Report to Sydney West Central Planning Panel

Panel reference	2017SWC006
DA number	SPP-16-04463
Proposed development	Subdivision, new public roads, 9 x residential flat buildings and a neighbourhood shop
Street address	41 Terry Road, Rouse Hill
Applicant	Sutherland and Associates Planning Pty Ltd
Landowner	Denvell Pty Limited
Date of DA lodgement	9 December 2016
Number of submissions	One
Regional development criteria (Schedule 4A of the EP&A Act)	Capital investment value (CIV) over \$20 million (DA has CIV of \$95.1 million)
All relevant s79C(1)(a) matters	<ul style="list-style-type: none"> • Sydney Regional Environmental Plan No. 20 – Hawkesbury-Nepean River • State Environmental Planning Policy (State and Regional Development) 2011 • State Environmental Planning Policy No. 55 – Remediation of Land • State Environmental Planning Policy No. 65 – Design Quality of Residential Apartment Development • State Environmental Planning Policy (Building Sustainability Index: BASIX) 2004 • State Environmental Planning Policy (Sydney Region Growth Centres) 2006 • Blacktown City Council Growth Centre Precincts Development Control Plan 2016 • Draft Central City District Plan

Report prepared by

Figure 2: Extract from the technical verification of the proposed plenum ducts to be applied to 13 apartments to achieve natural cross ventilation.

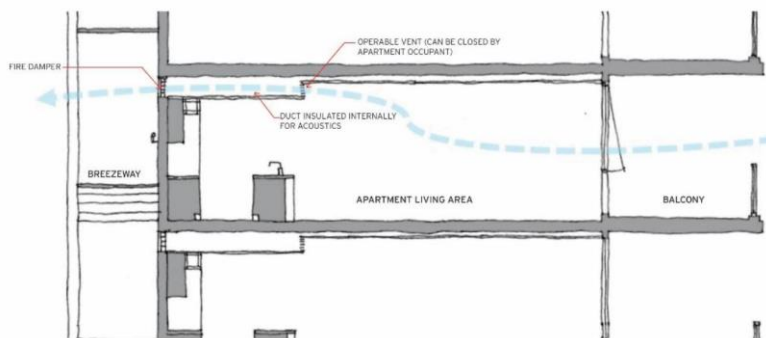
- a. To achieve natural cross ventilation to at least 60% of the total of 332 apartments, as required by Part 4B Natural Ventilation of the ADG, the following alternate techniques are proposed:
 - 13 apartments on the Ground Level, Level 1 and Level 2 rely on the use of plenum ducts, being 4 % of the apartments. Plenum ducts are a space

between the structural ceiling and the dropped ceiling that can facilitate air circulation

- 42 apartments on Level 3 (the top level) rely on rooftop ventilating skylights, being 13 % of the apartments.
- b. The Applicant has submitted technical verification of the effectiveness of the proposed plenum ducts to provide natural cross ventilation, prepared by Windtech Consultants and provided at Attachment 12. Figure 2 below demonstrates this design.

- c. The overall development is considered to achieve a suitable level of amenity through natural cross ventilation, subject to these alternate techniques. Subject to conditions to ensure that these ventilation methods are appropriately installed and reflect the relevant fire safety and acoustic requirements, residents' access to natural cross ventilation is acceptable in this instance.
